Technical Service Bulletin

40 Clicking noise from wheel bearing

40 12 26 2024318/2 September 26, 2012. Supersedes Technical Service Bulletin Group 40 number 10 – 13 dated December 21, 2010 for reasons listed below.

Figure 1. Area to apply paste.

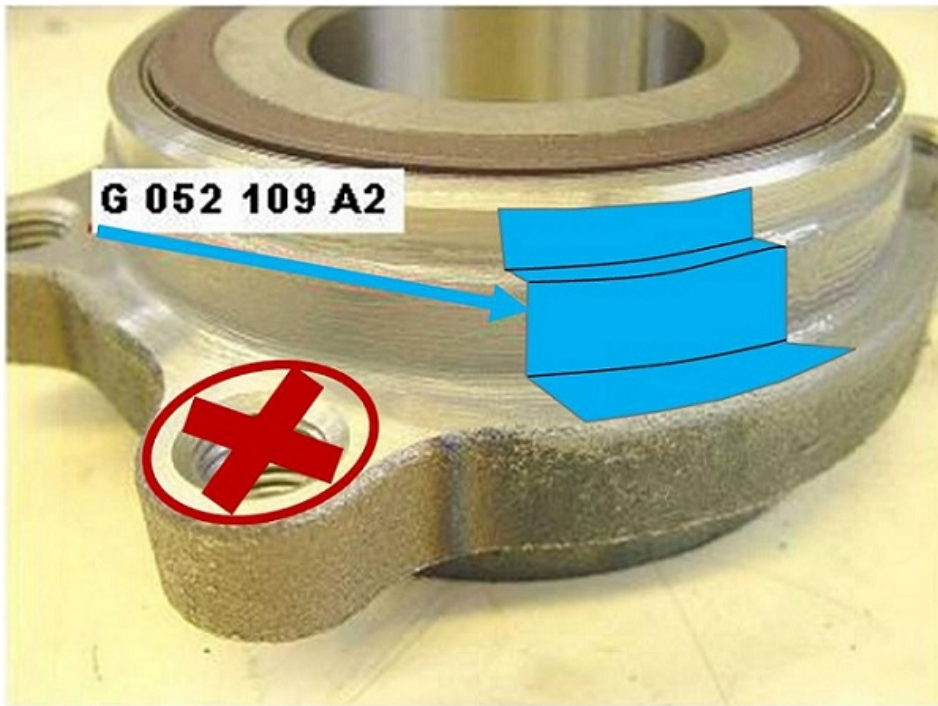
1. Remove any corrosion and dirt from the wheel bearing housing and the wheel bearing.
2. Using a brush, apply a thin coat of paste **G 052109A2** on the wheel bearing housing as shown in Figure 1. Make sure not to apply any paste on the threads.
